UNITED STATES
DEPARTMENT OF THE INTERIOR
GEOLOGICAL SURVEY

SUNDRY NOTICES AND REPORTS ON WELLS

(other) Move Location 45' West

5. LEASE
SF 080724 A
6. IF INDIAN, ALLOTTEE OR TRIBE NAME
7. UNIT AGREEMENT NAME
8. FARM OR LEASE NAME
Zachry
9. WELL NO.
15-E
10. FIELD OR WILDCAT NAME
Wildcat Gallup - Basin Dakota
11. SEC., T., R., M., OR BLK. AND SURVEY OR AREA
Sec. 33, T-29N, R-10W, N.M.P.M.
12. COUNTY OR PARISH
San Juan
13. STATE
New Mexico
14. API NO.
15. ELEVATIONS (SHOW DF, KDB, AND WD)
5621 GR.

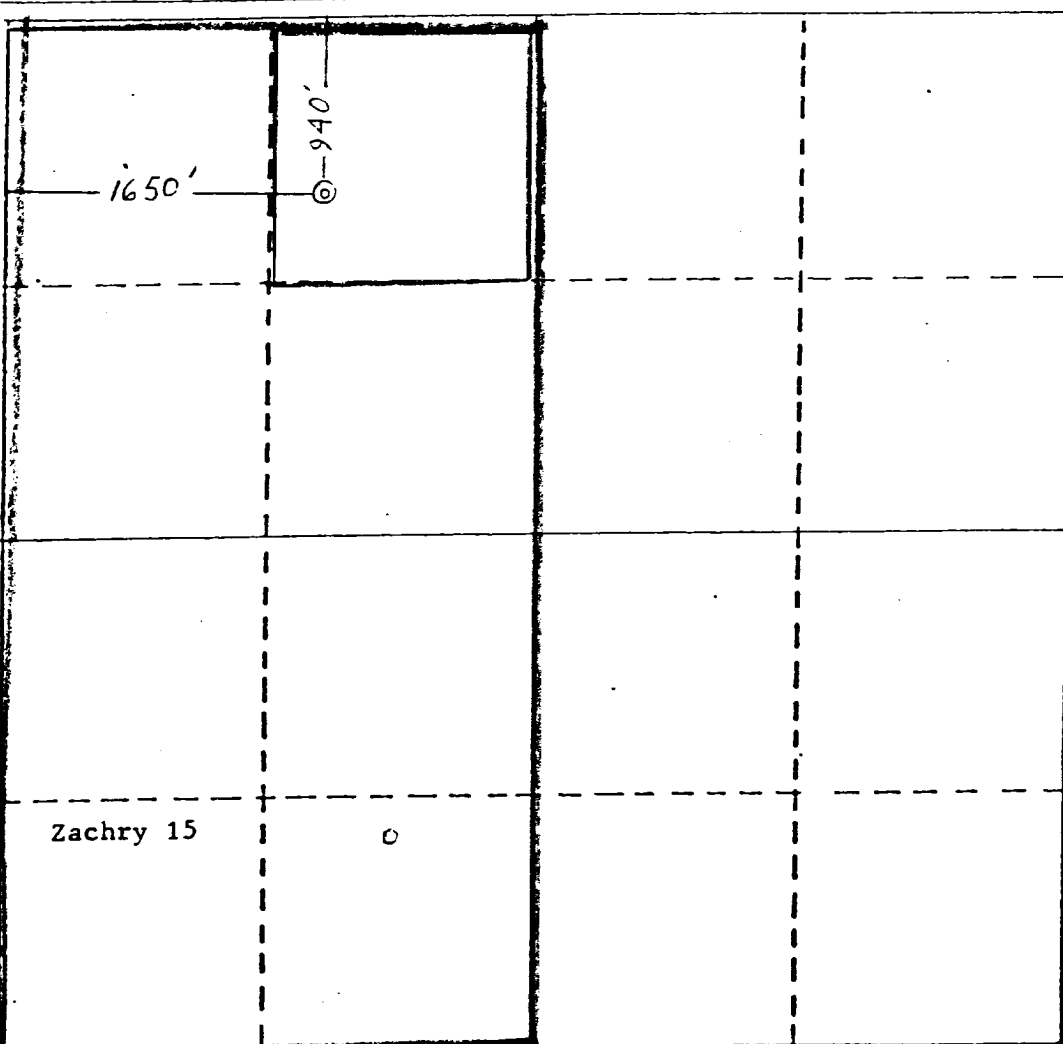
We desire to move location 45 feet West of the approved site to make this location legal for a Wildcat Gallup and Dakota zone dual completion (See new attached dedication plat). Change pipe from 4-1/2", 10.50# csg. to 5-1/2", 15.50# csg. to be set at approx 6540 ft. after logging. Cement 1st stage as follows: Bring cmt up to approx 5990 ft. K.B. 550 ft. of 7-7/8" hole X 5-1/2" csg. = 550' X 0.1733 = 95 cu. ft. use 35% for hole washout = slurry volume = 128 cu ft. Run 128 cu ft. cement slurry + shoe jt. volume to bring cement to 5990 ft. This volume may vary depending on caliper of hole after logs are run. 2nd stage - 1st D.V. tool at approx 5410 ft. Cement to cover Mesaverde: 5410 ft. to 3300 ft. = 2110' X 0.1733 = 366 cu. ft. use 50% excess for hole washout - slurry volume 550 cu ft. to bring cement to 3300 ft. 3rd stage - 2nd D.V. tool at approx 3040 ft. Cement with approx 200 sx of 65-35 followed by 50 sx of class "B" cement and cover the Ojo Alamo zone. Pressure test the casing. Perforate and fracture the Dakota zone and set a bridge plug above the Dakota zone. (Con't - See Attachment)
